**CCB 6917**  
**Pre and Post Change Summary**  
**PCN #: NTDO-13PLGV705**

# LEAD FRAME COMPARISON

## ASE

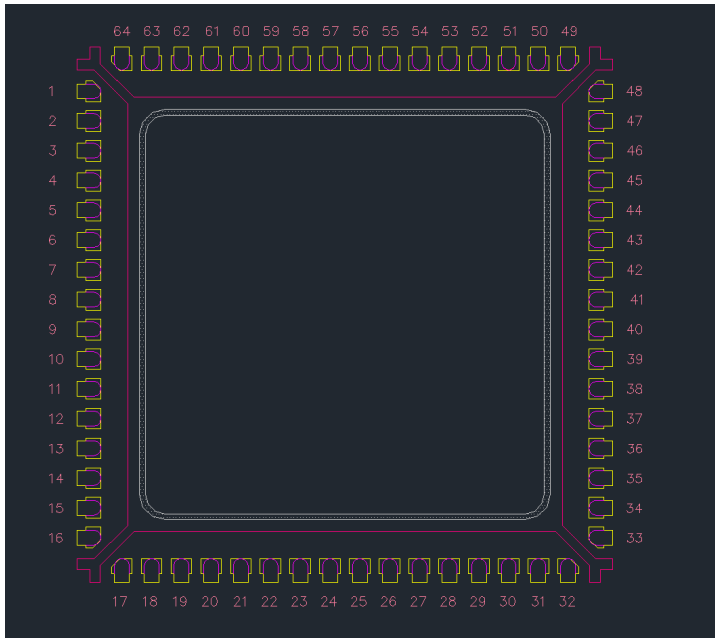
Lead Frame Material	C194
Paddle size	287 x 287 mils
DAP Surface Prep	Ag ring plated

## MTAI

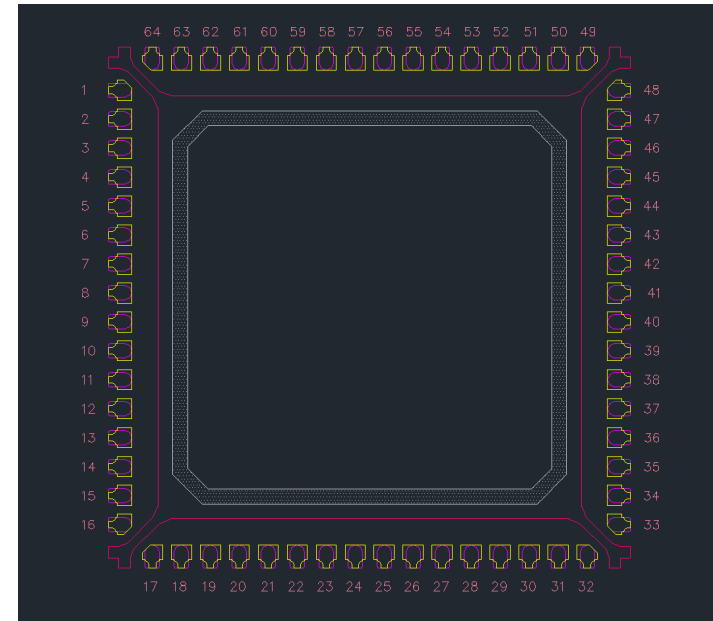
Lead Frame Material	A194
Paddle size	287 x 287 mils
DAP Surface Prep	Ag ring plated

**Note:** \*C194, A194 or CDA194 Lead frame material are the same, it is just a MCHP internal labelling difference.
